**DEPARTMENT OF TRANSPORTATION
STATE OF GEORGIA**

FILE: STP00-2009-00(004) **OFFICE:** Engineering Services
 Clayton & Fayette Counties
 P.I. No.: 742870-
 SR 920 from SR 54 to SR 3/US 19 **DATE:** August 23, 2013

SUBJECT: IMPLEMENTATION OF VALUE ENGINEERING STUDY ALTERNATIVES

Regarding: Value Engineering Study Responses
Project No. STP00-2009-00(004), PI No. 742870
Fayette/Clayton Counties

R-2.0 : REVISED TYPICAL FOR MULTI-USE PATH

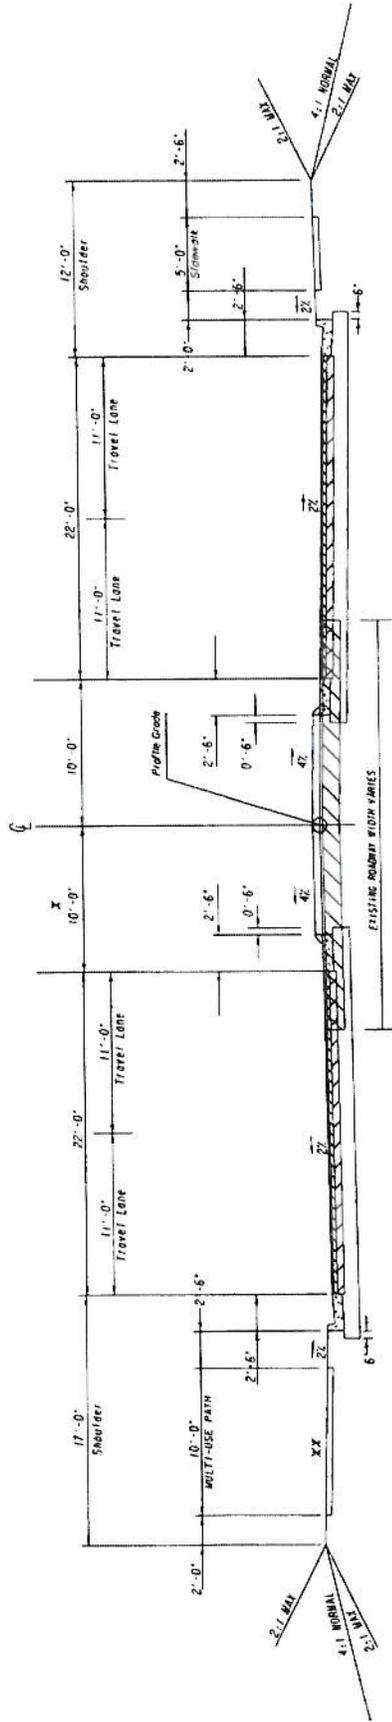
5) Recommendation R-2.0: Use 10' Wide Multi-use Trail on One Side with 5' Wide Sidewalk on Opposite Side in lieu of Bike Lanes and Sidewalks

Yes, we will implement the recommendation with modifications and reduced savings. The recommendation's typical section shows a 1' outside shoulder; however, the 2012 AASHTO Guide for the Development of Bicycle Facilities states that "At a minimum, a 2 ft (0.6 m) graded area with a maximum 1V:6H slope should be provided for clearance from lateral obstructions such as bushes, large rocks, bridge piers, abutments, and poles." Using a 2 ft outside shoulder per the AASHTO guideline will shift the required right-of-way line out an additional foot, thus decreasing the cost savings. An additional reduction in the cost savings will occur by implementing this recommendation as the 4' bicycle lanes were being used for maintenance of traffic especially in areas where the there are grade changes and/or the proposed and existing edge of pavements are near one another. However, the project has not progressed far enough along to identify the specific areas where this will occur; therefore, the actual reduction in cost savings cannot be calculated at this time.

Revised Savings: \$1,265,041

xNOTE: VARIES FROM 10'0" TO 20'0"
 STA. 744+63.00 TO 762+75.64

xx NOTE: MULTI-USE PATH ON NORTH SIDE OF
 SR 920/MCDONOUGH ROAD FROM SR 54 TO
 PANHANDLE ROAD AND ON THE SOUTH SIDE
 OF SR 920/MCDONOUGH ROAD FROM PANHANDLE
 ROAD TO CLAYTON COUNTY PARK ENTRANCE EAST
